RE: Docket No. 466: Frost Bridge to Campville 115-kV Project
Development & Management Plan Volume 3 Update: Change Notice Requests

Modifications to Above-Ground Heights of Direct Embed Structures (Per Eversource Requirements for Foundation Depth in Rock) Towns of Watertown, Thomaston, Litchfield, and Harwinton; Various Volume 3 Mapsheets

Temporary Structures and Associated Temporary Guys to Facilitate Modifications to the 1191 and 1921 Line Separation at the Naugatuck River Crossing Mapsheets 30 and 33, Towns of Litchfield and Harwinton, Respectively

Modifications/Increase in Vegetation Removal Limits Naugatuck River Valley (West Side Removal Limits) and North of Valley Road Town of Harwinton, Mapsheets 31 and 32

Figure 4-2: Comparison of Vegetation Removal Limits: July 2016 and Proposed January 2017
(Excerpts from D&M Plan Mapsheets 31/32)

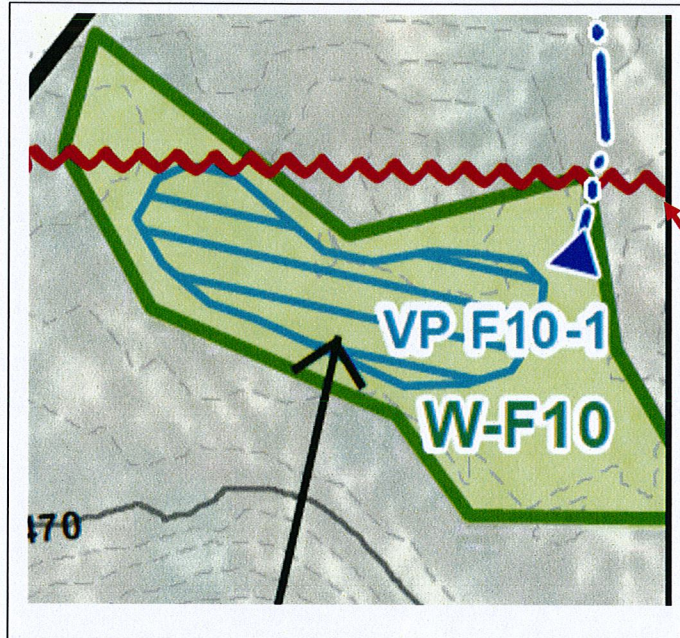
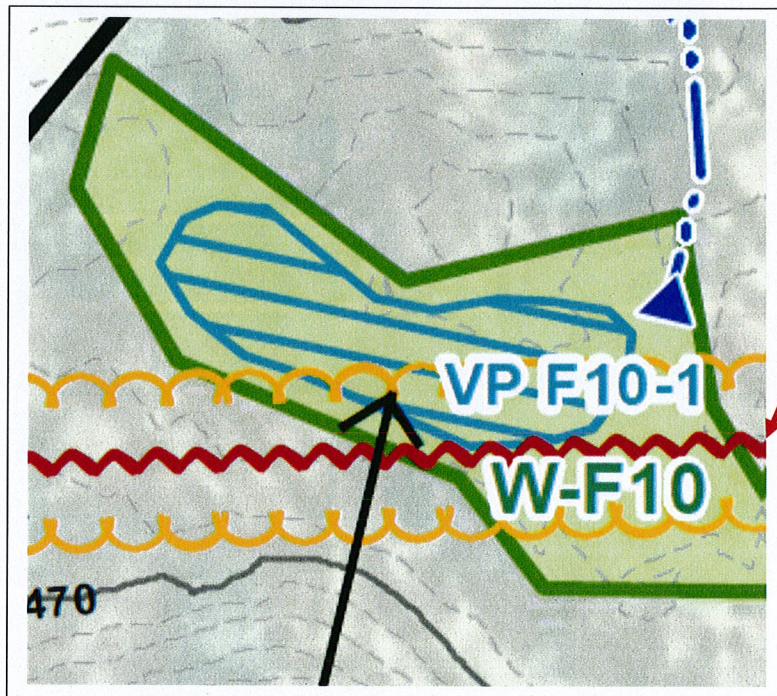
1. The western vegetation removal limits (within the ROW, near the existing 1191/1921 lines), as depicted on Mapsheet 31 of the July 2016 D&M Plan, were not illustrated as required, and did not reflect the full 45-foot width between the centerlines of the new 1304 Line structure and new 1921 Line structures. The correct vegetation removal limits in this location are depicted on the January 2017 version of Mapsheet 31. As this updated mapsheet shows, additional vegetation removal now will be required within and near Connecticut-wetland W-F9 and of a small vernal pool (VP-F9-1). This vernal pool, occupies approximately 0.0075 acre.

2. Additional vegetation removal will be required within the eastern portion of the ROW between Valley Road and Structure 87. To maintain conductor clearances in this area, approximately 0.053 acre of additional forest vegetation would have to be removed within vernal pool VP-F10-1 and wetland W-F-10. Of the 0.053 acre of additional tree clearing, 0.024 acre would be within the vernal pool.

At the Naugatuck River crossing, the July 2016 Mapsheet 31 depicted an approximately 30-foot-wide vegetation removal limit along the west side of the new 1304 Line structures. This depiction is inconsistent with the clearing limits depicted on XS-5, which identify a 45-foot width in this area. The January 2017 Mapsheet 31 provides the correct vegetation removal limits, as illustrated on XS-5.

To comply with the mandated conductor clearance requirements, additional vegetation removal within VP-F10-1 is required. The January 2017 D&M Plan Volume 3, Mapsheets 31 and 32, reflect these increased vegetation removal limits. To facilitate a comparison of the proposed and previously-approved vegetation removal in this area, Figure 4-2 includes excerpts of the vegetation removal limits depicted on the approved July 2016 maps and as proposed on the January 2017 maps.

To conduct the additional vegetation removal in VP-F10-1/W-F10, Eversource proposes to stage the vegetation removal work in adjacent upland areas. Tree clearing adjacent to the pool will be limited to a few additional trees along the pool's southern and eastern banks. Where present, existing scrub-shrub vegetation within 25 feet of the vernal pool will be maintained.
